Proposal to amend document ECE/TRANS/WP.29/GRBP/2024/7

I. Proposal

Figure 1
Nomenclature explanation related to grip index of the tyre

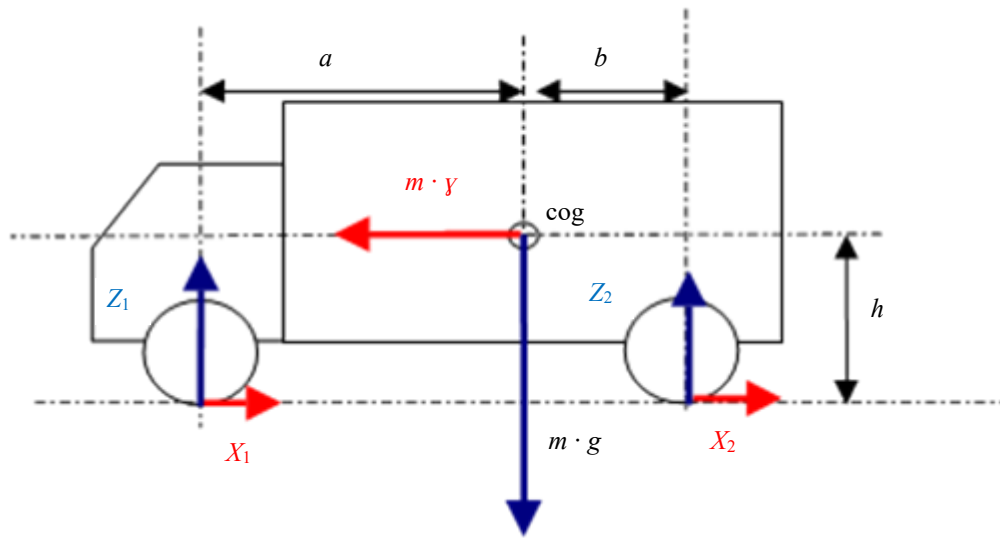
"2.2.2.7.5. Calculation of the relative wet grip index of the tyre

The wet grip index represents the relative performance of the candidate tyre compared to the reference tyre. The way to obtain it depends on the test configuration as defined in paragraph 2.2.2.2. of this Annex. The wet grip index G of the tyre is calculated as reported into Table 7:

Configuration C1: candidate tyres on both axles	$G = f \cdot \frac{BFC(T)}{BFC(R)}$
Configuration C2: candidate tyres on front axle and reference tyres on rear axle	$G = f \cdot \frac{BFC(T) \cdot [a + b + h \cdot BFC(R)] - a \cdot BFC(R)}{BFC(R) \cdot [b + h \cdot BFC(T)]}$
Configuration C3: reference tyres on front axle and candidate tyres on rear axle	$G = f \cdot \frac{BFC(T) \cdot [-a - b + h \cdot BFC(R)] + b \cdot BFC(R)}{BFC(R) \cdot [-a + h \cdot BFC(T)]}$

<i>For class C2 tyres</i>	
SRTT16C	
$f = 1$	
<i>For class C3 tyres</i>	
SRTT19.5, SRTT22.5	SRTT19.5 siped, SRTT22.5 siped
$f = 1$	$f = 1.041.02$

f: correction factor depending on used SRTT

9. According to the test results which is reported in informal document GRBP-78-28-Rev.1, the correction factor (f) depending on used SRTT for the wet grip index in new state (G) should be replaced to 1.02 instead of 1.04 in order to minimize the relaxation or tightening of requirement.
